THE GARDENS AT NORTH CAREFREE CONSTRUCTION DRAWINGS EL PASO COUNTY, STATE OF COLORADO

| GARDENS AT NORTH CAREFREE TITLE SHEET | |

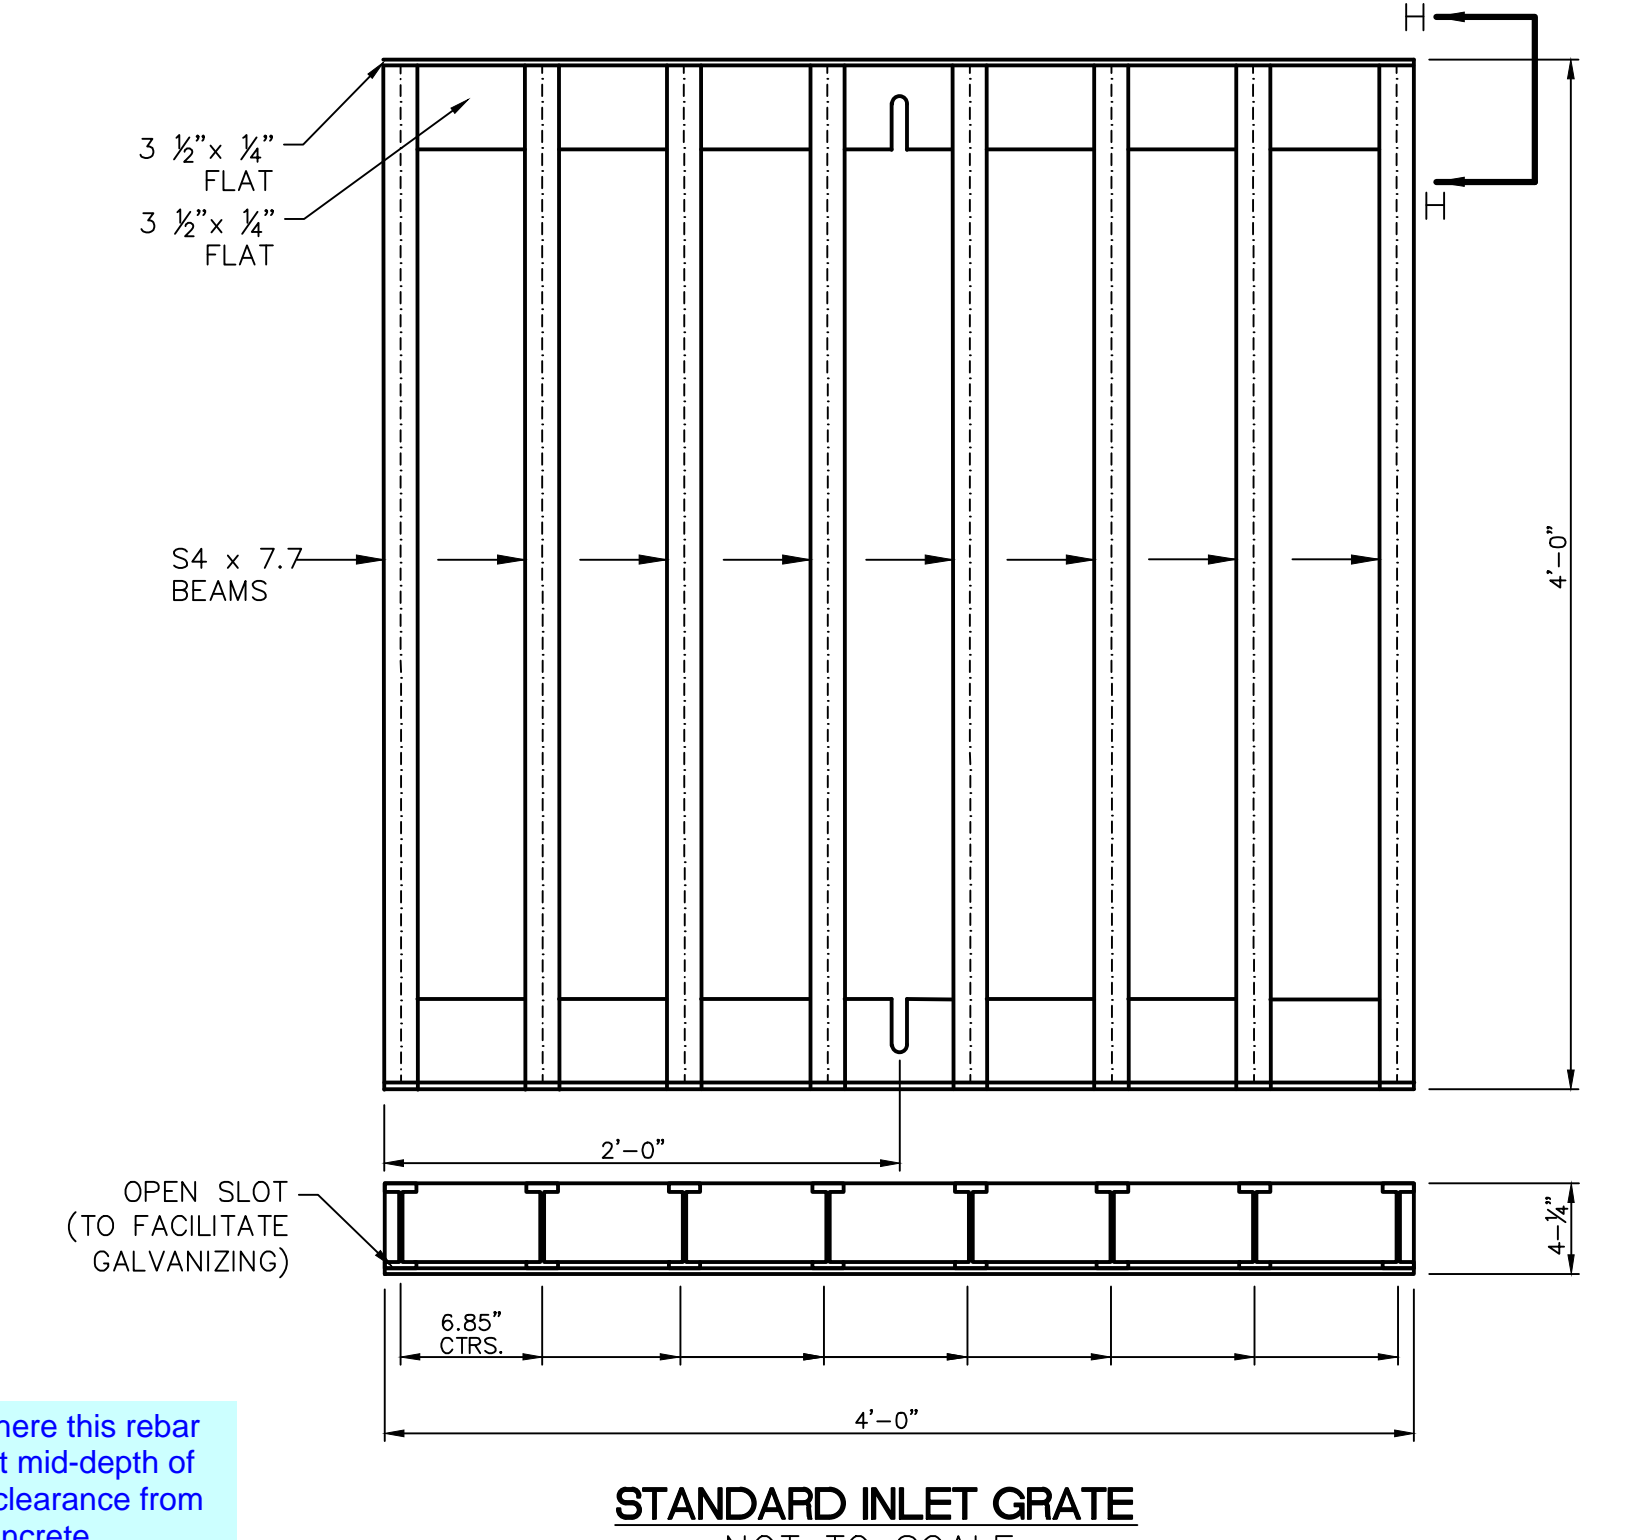
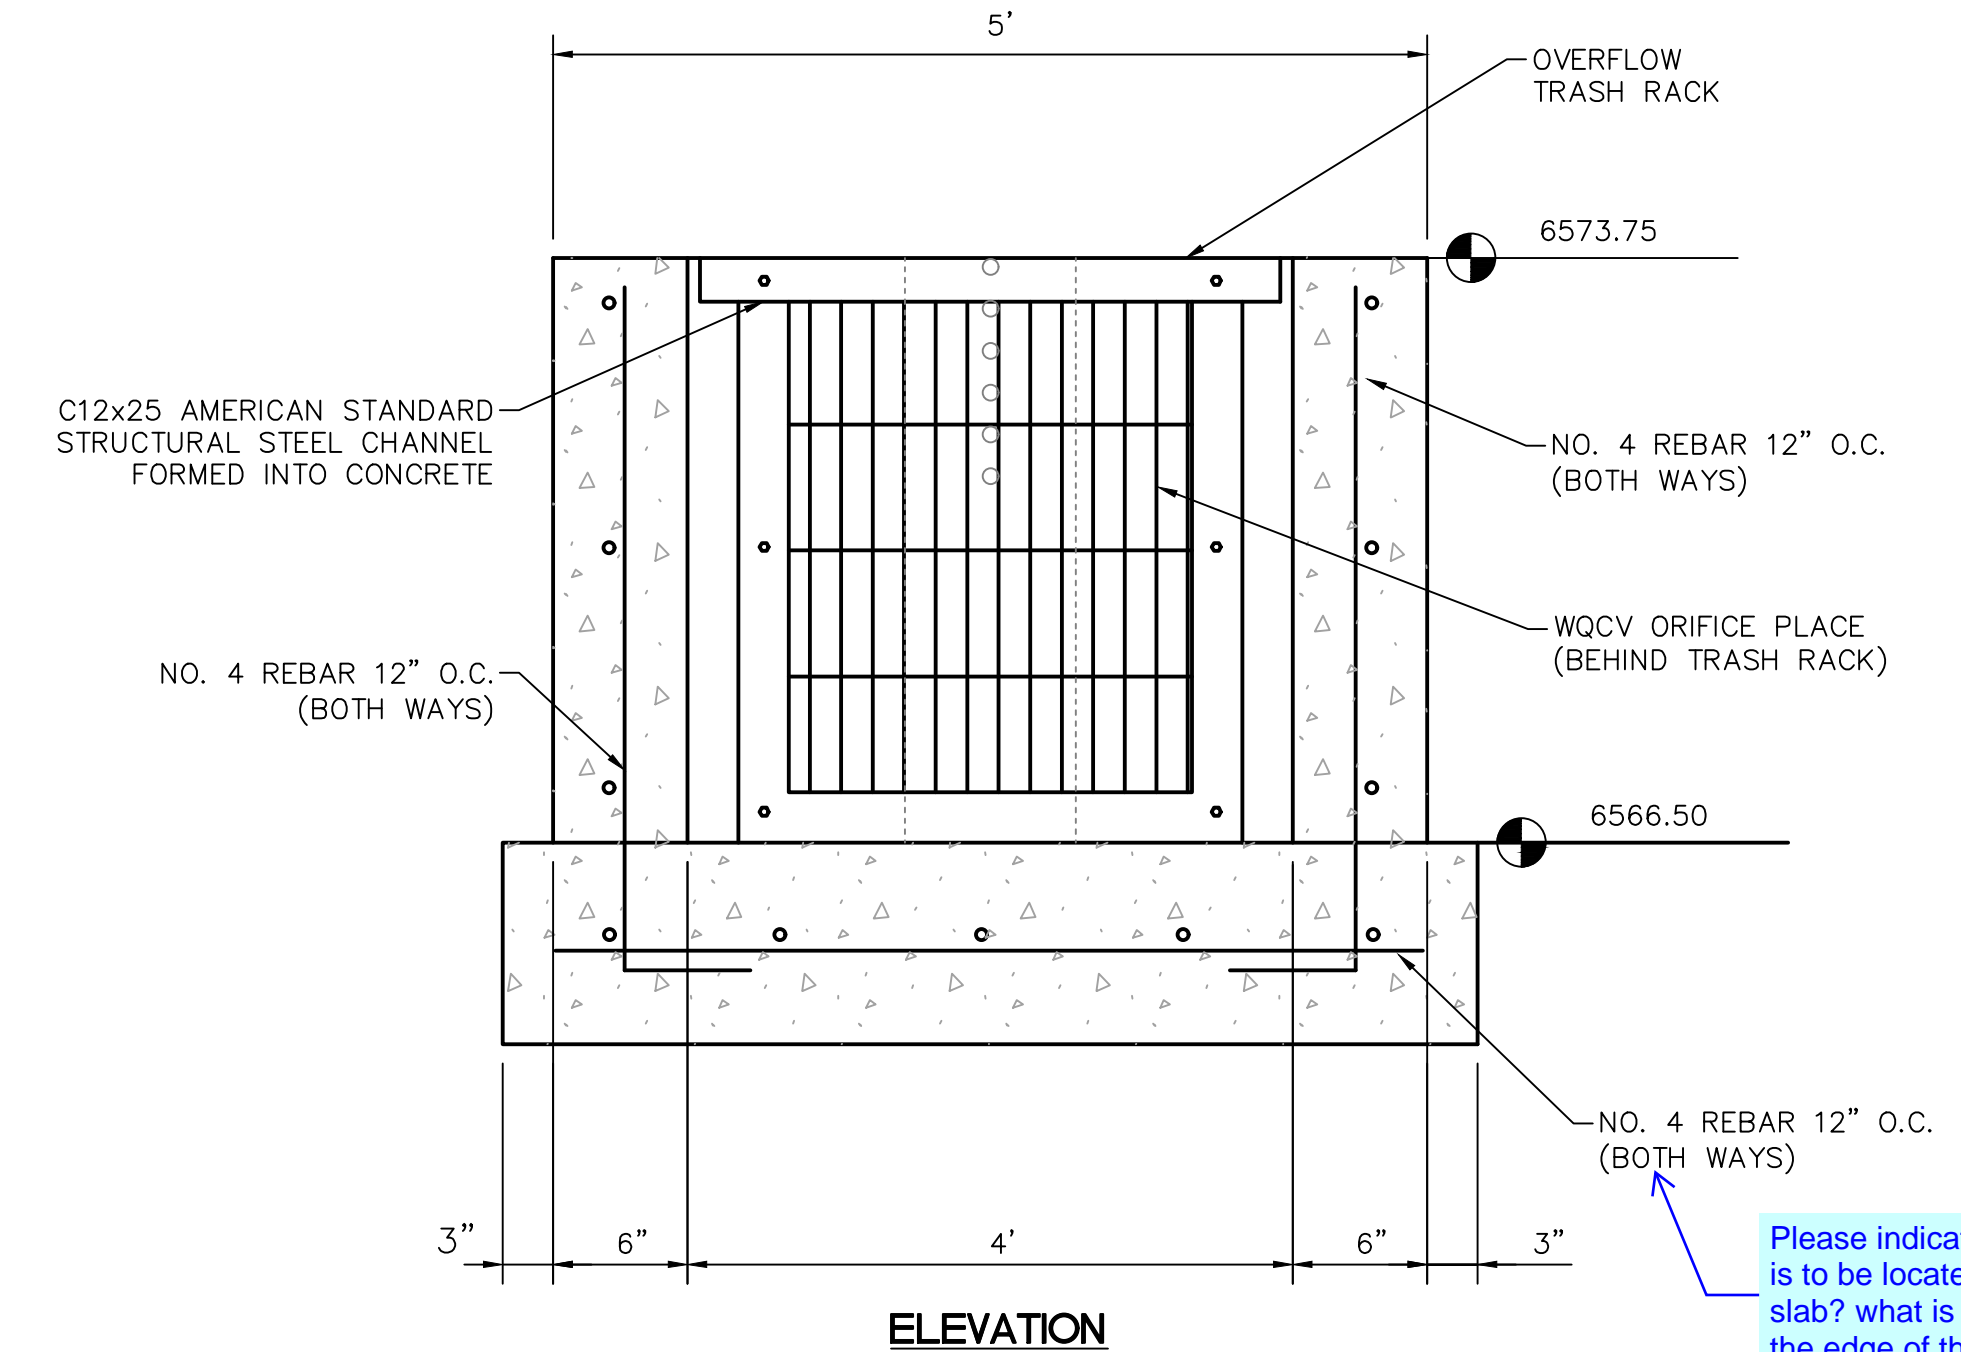
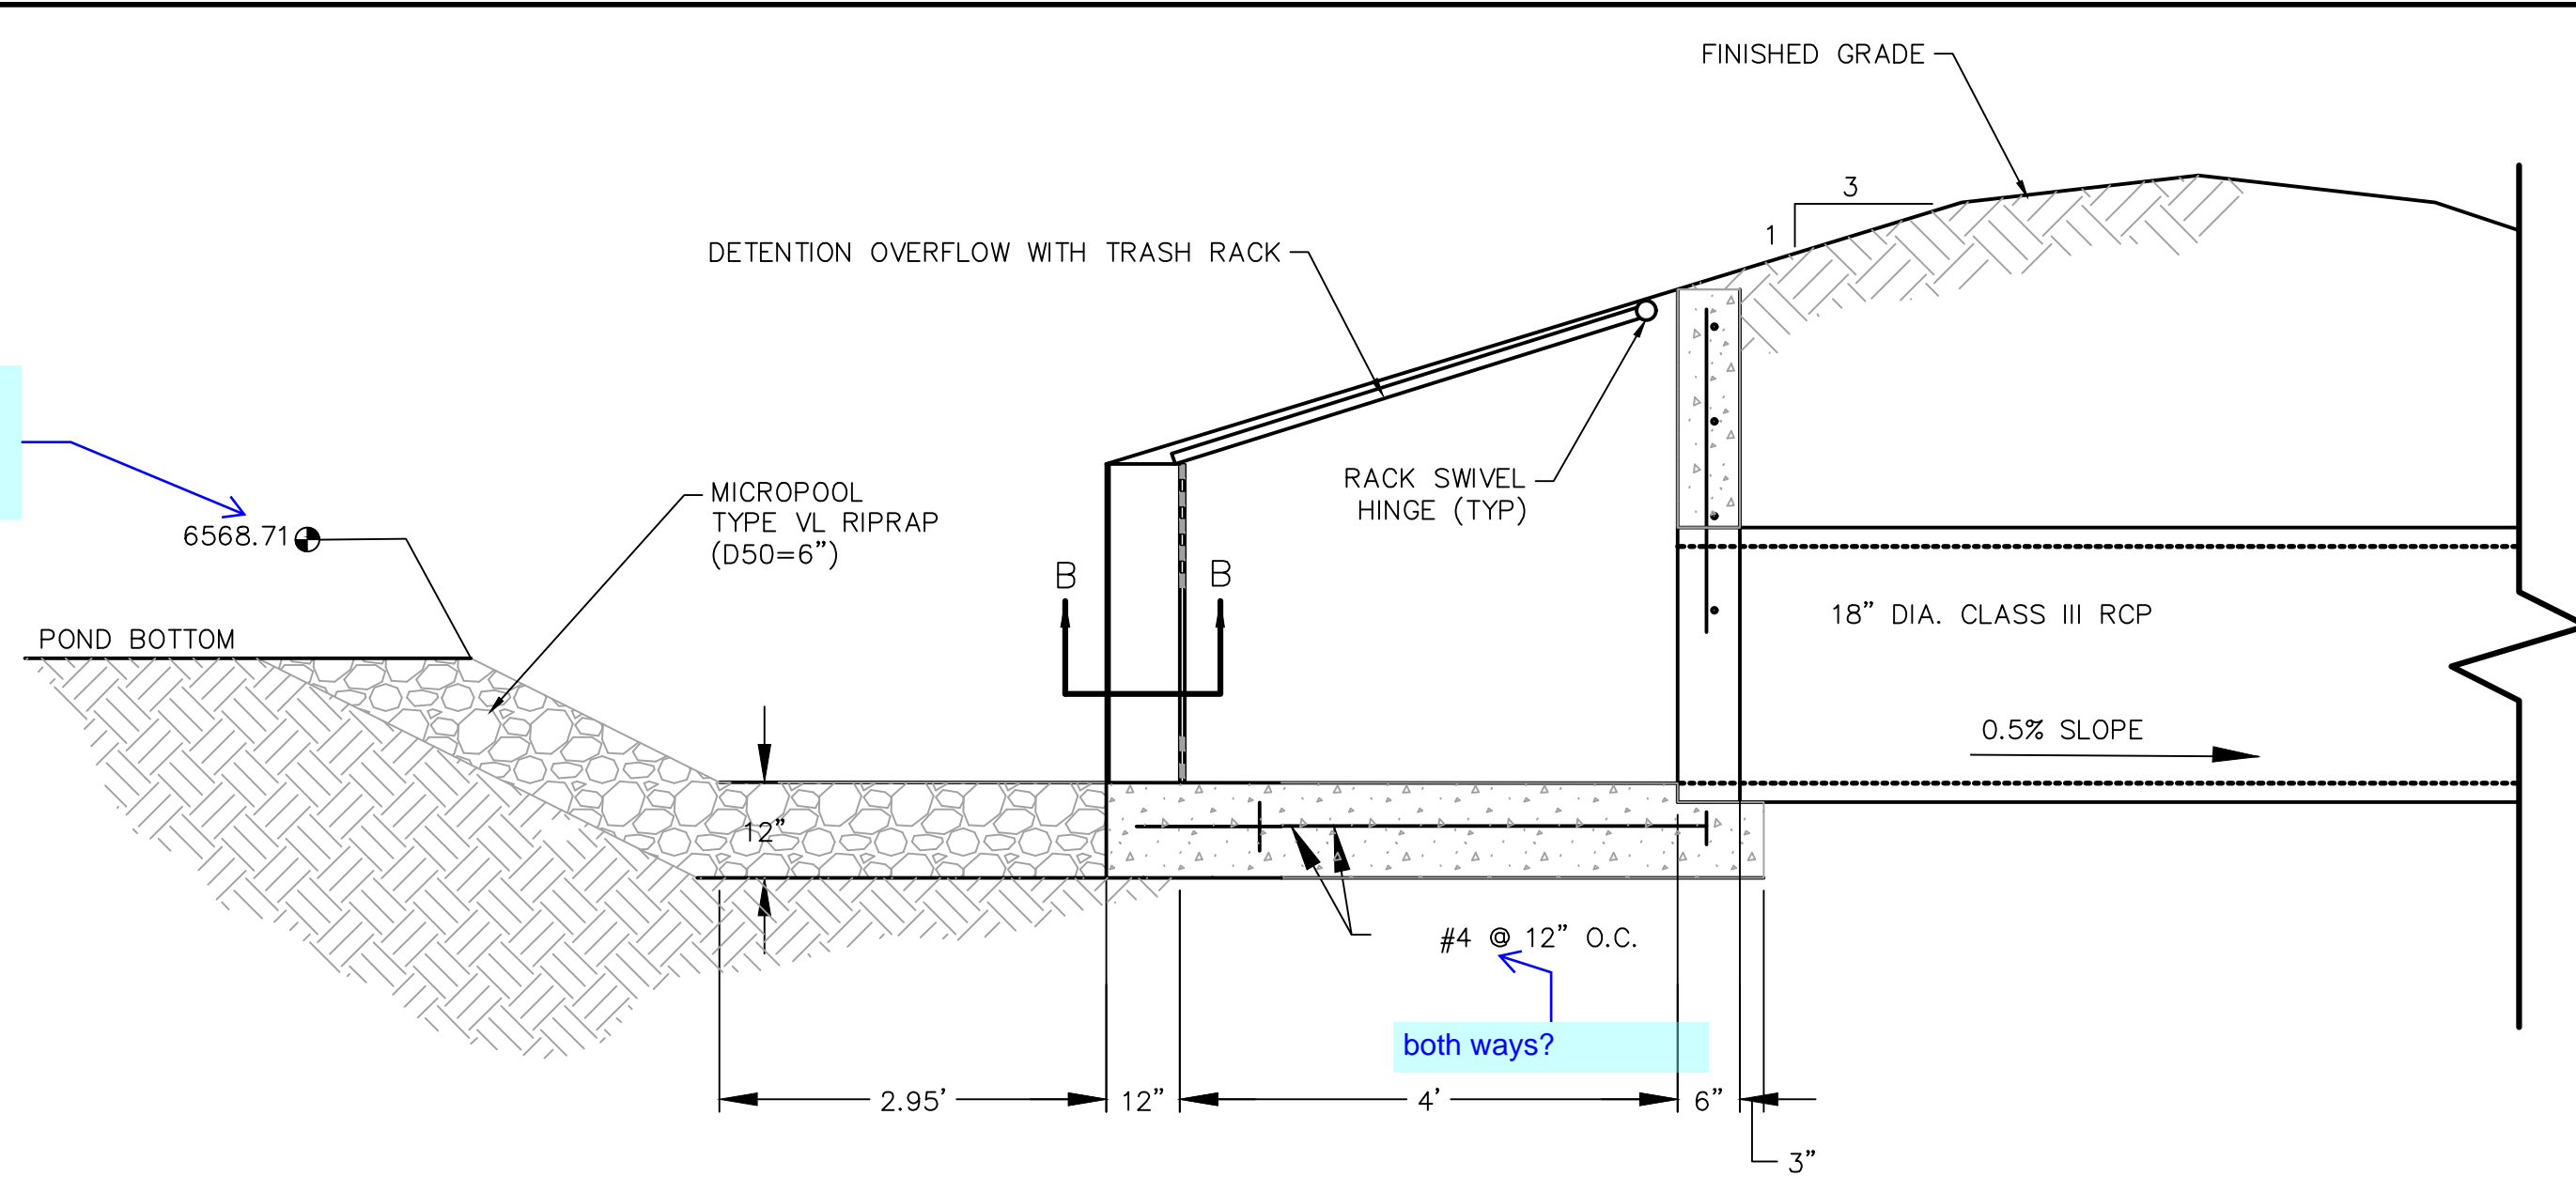
doesn't match elevation shown on the profile. revise accordingly.

The micropool shall be a minimum of 2.5 ft in depth. Revise elevations accordingly so that they match the design calculations

Bottom of micropool? This doesn't match what is shown on the profile. Staff recommends adding labels to the elevations shown on this page and the south pond detail page.
